C Section 75W Submission 19.07.12
 B EA Submission 18.12.09
 A submitted for Test of Adequacy 09.11.09

MERITON THOMAS STREET
 Thomas Street/ Albert Avenue
 Chatswood NSW 2067

NORTH ELEVATION

A-0121 C
 SECTION 75 W SUBMISSION

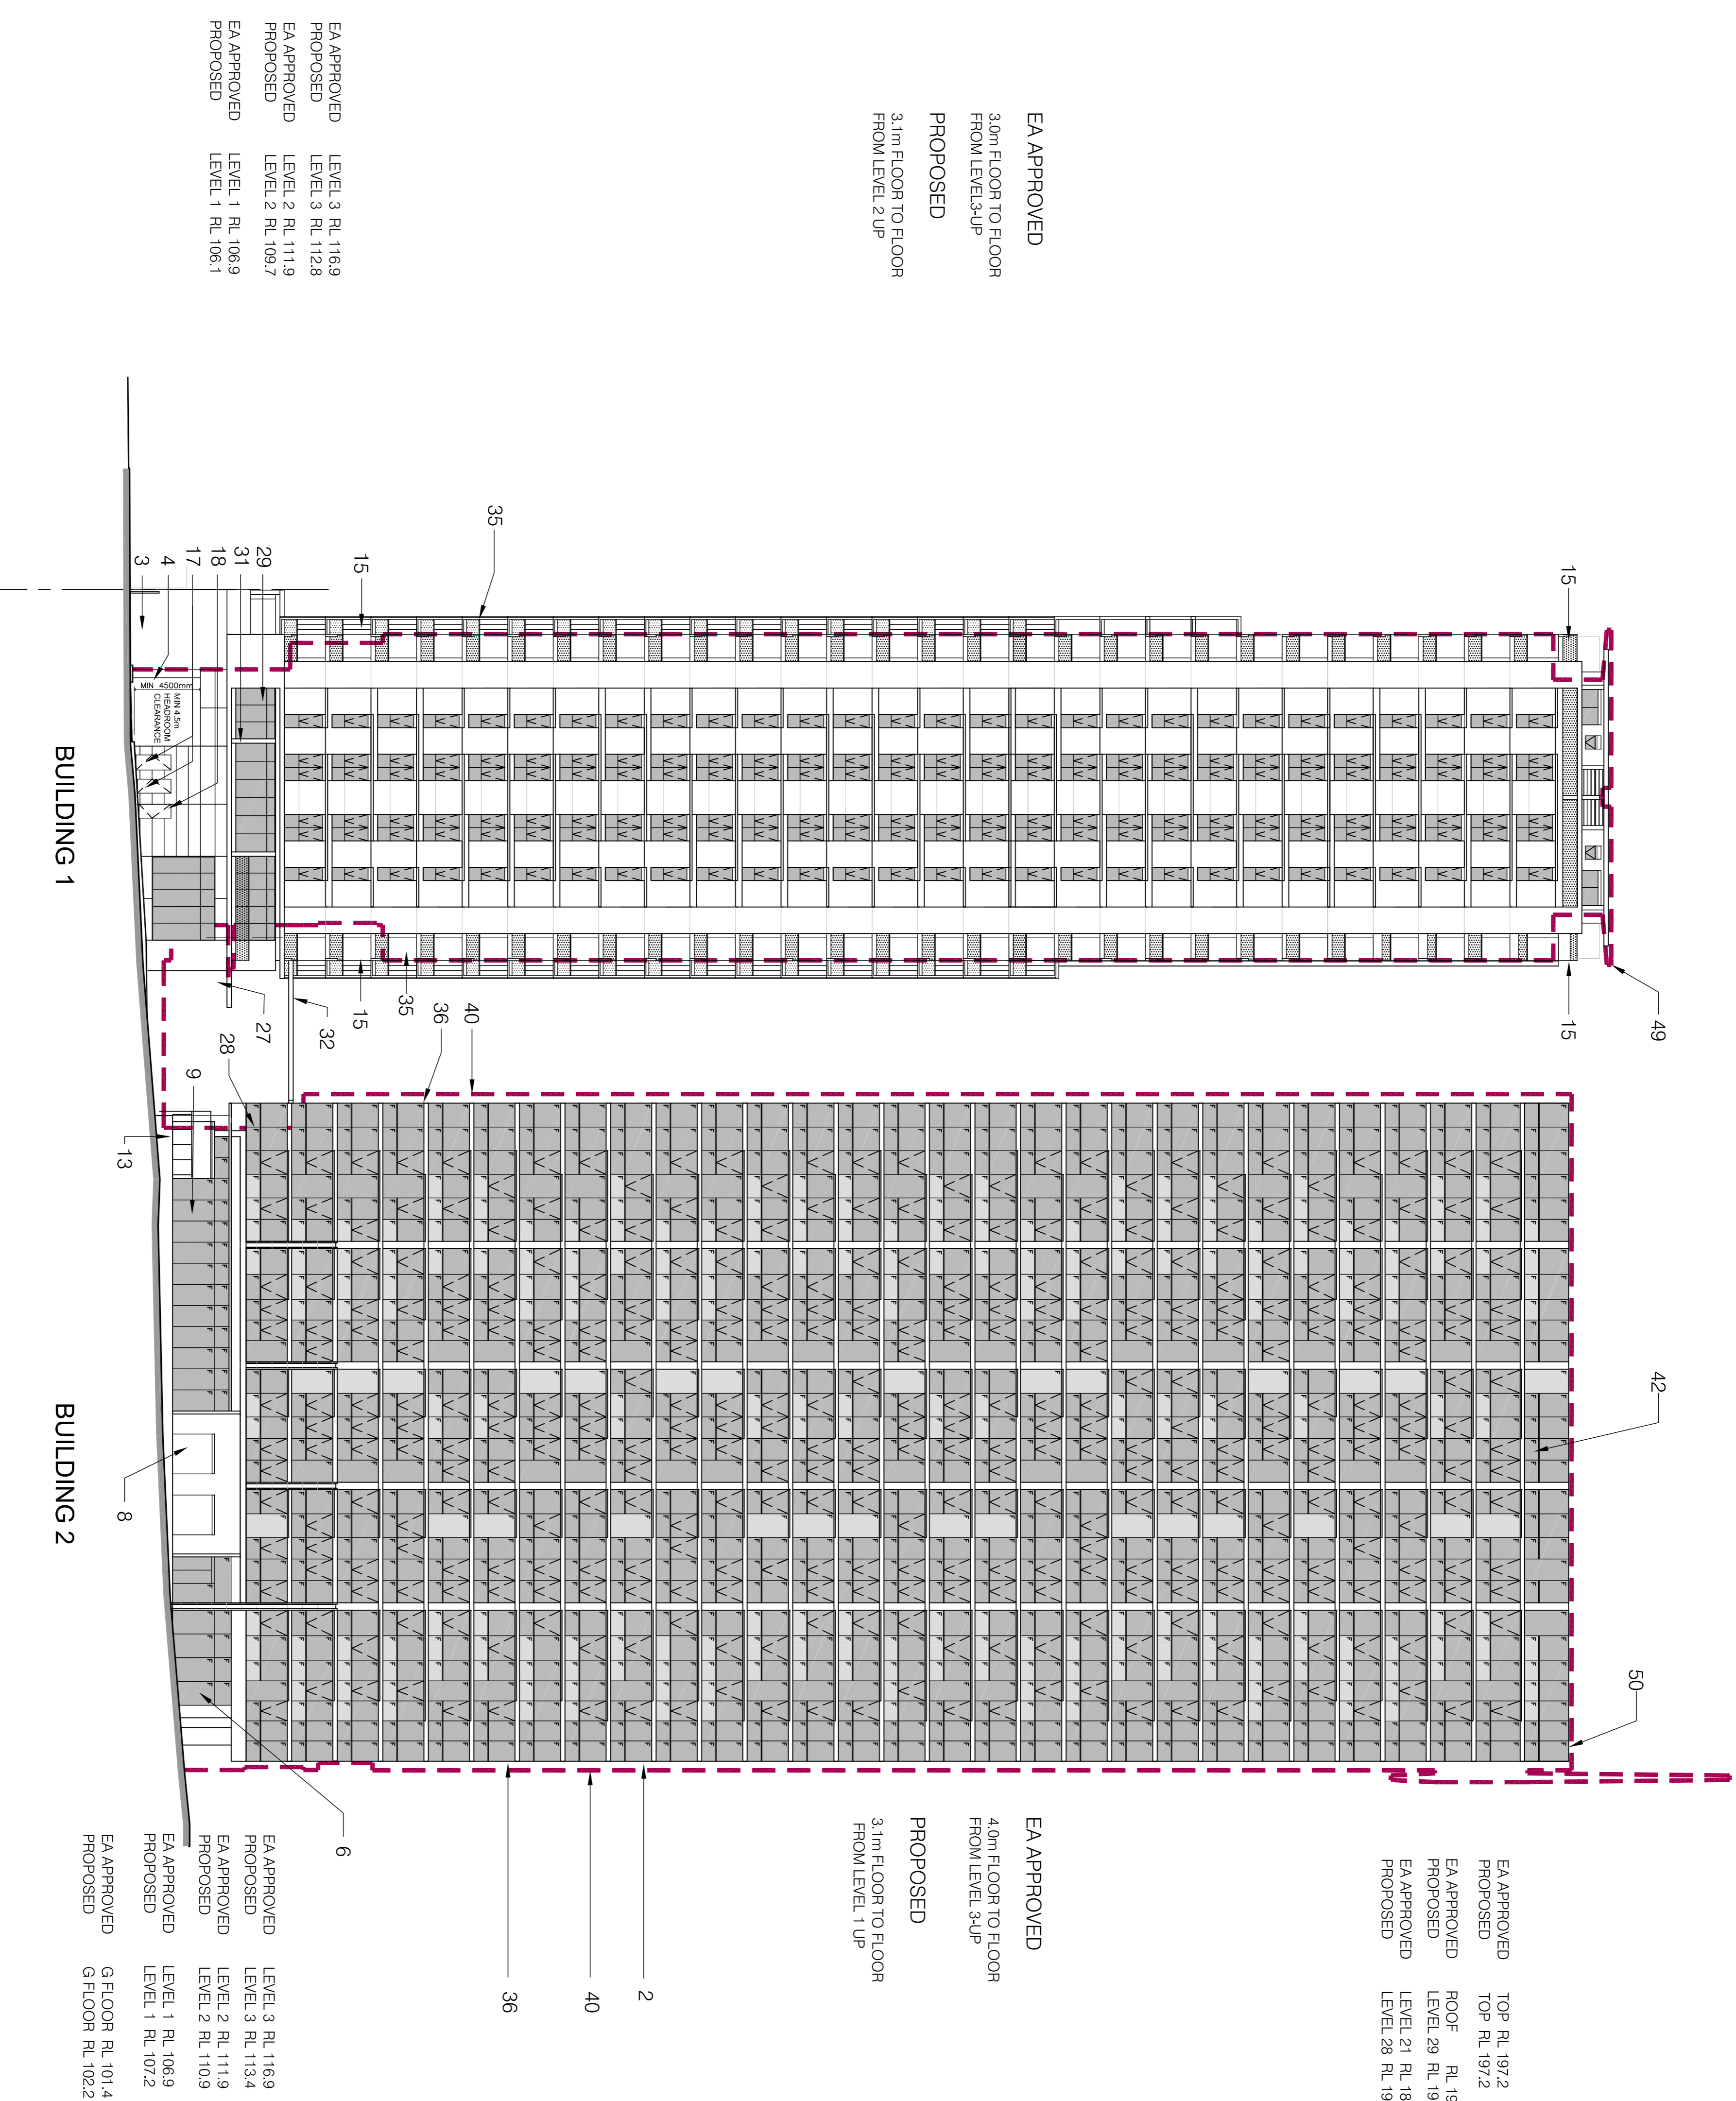
2. CHANGE OF USE FROM COMMERCIAL TO SERVICED APARTMENTS - SK-006c
3. ADDITIONAL VEHICLE EXIT FROM BASEMENT 1 TO THE THOMAS STREET FRONTAGE - SK-003
4. RIGHT OF WAY FROM FLEET LANE - SK-002

6. PORTE COCHERE ADDED
8. SUBSTATION RELOCATED
9. GROUND FLOOR TO SERVICED APARTMENT REDESIGNED
13. S/A RISER ROTATED & INCREASED
15. BUILDING OUTLINE EXTENDED

17. FIRE CONTROL ROOM & FIRE EGRESS REDESIGNED
18. FIRE EGRESS FROM TOWER RELOCATED
27. AWNING RELOCATED & REDESIGNED FROM GLAZED TO COMPOSITE PANEL CLAD

28. AWNING DELETED
29. RETAIL DELETED
31. SWIMMING POOL, RELOCATED FROM LEVEL 2 TO LEVEL 1
32. GLASS CANOPY REDUCED AND REDESIGNED
35. PRIVACY SCREENS TO LEVEL 3-5 AS PER SK-001 AND TO LEVELS 3-18 AS PER SK-010

36. FLOOR PLATE REDUCED
40. EA APPROVED COMMERCIAL BUILDING ENVELOPE
42. PLANT ROOM REDUCED.
49. OUTLINE OF TOWER, EA APPROVED OUTLINE OF RESIDENTIAL TOWER

50. EA APPROVED HEIGHT SERVICED APARTMENTS RL 197.2 RESIDENTIAL TOWER RL 199.9

- EA APPROVED LEVEL 3 RL 116.9 PROPOSED LEVEL 3 RL 112.8
- EA APPROVED LEVEL 2 RL 111.9 PROPOSED LEVEL 2 RL 109.7
- EA APPROVED LEVEL 1 RL 106.9 PROPOSED LEVEL 1 RL 106.1

- EA APPROVED TOP RL 197.2 PROPOSED TOP RL 197.2
- EA APPROVED ROOF RL 194.9 PROPOSED LEVEL 29 RL 194.2
- EA APPROVED LEVEL 21 RL 189.2 PROPOSED LEVEL 28 RL 190.9

- EA APPROVED LEVEL 3 RL 116.9 PROPOSED LEVEL 3 RL 113.4
- EA APPROVED LEVEL 2 RL 111.9 PROPOSED LEVEL 2 RL 110.9
- EA APPROVED LEVEL 1 RL 106.9 PROPOSED LEVEL 1 RL 107.2
- EA APPROVED G FLOOR RL 101.4 PROPOSED G FLOOR RL 102.2
